SUBJECT: ISSUANCE OF AMENDMENT FOR INDIAN POINT NUCLEAR GENERATING UNIT NO. 3
(TAC NO. M96086)

ISSUANCE OF AMENDMENT NO. 170 TO FACILITY OPERATING LICENSE NO. DPR-28

AMENDMENT TO FACILITY OPERATING LICENSE

SAFETY EVALUATION BY THE OFFICE OF NUCLEAR REACTOR REGULATION
RELATED TO AMENDMENT NO. 170 TO FACILITY OPERATING LICENSE NO. DPR-64
POWER AUTHORITY OF THE STATE OF NEW YORK
INDIAN POINT NUCLEAR GENERATING UNIT NO. 3
DOCKET NO. 50-286

FIGURE 2.1-1

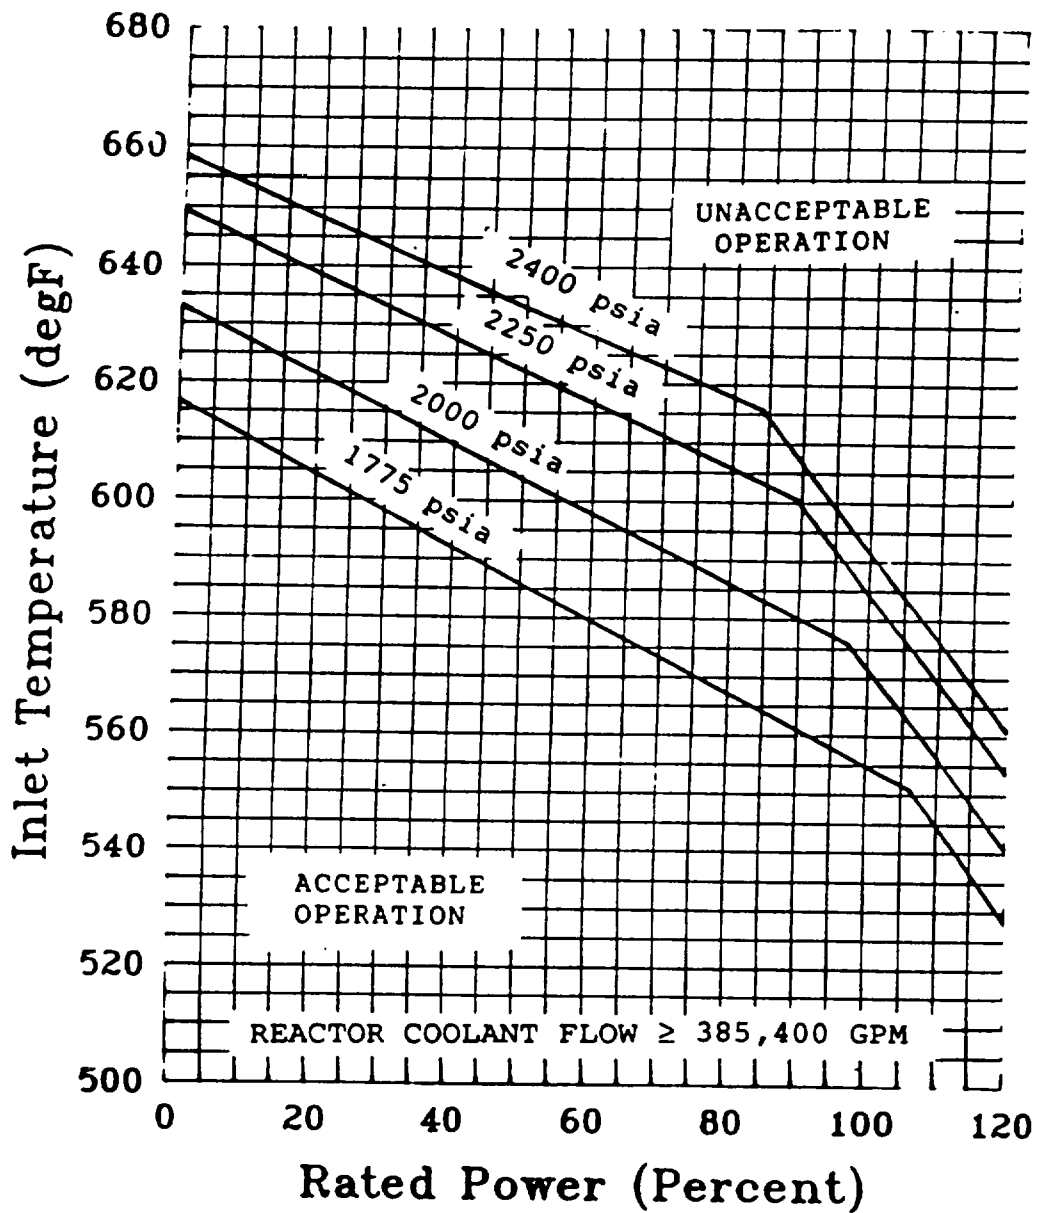
This curve does not provide allowable limits for normal operation.
(See Technical Specification 3.1.H for DNB limits)
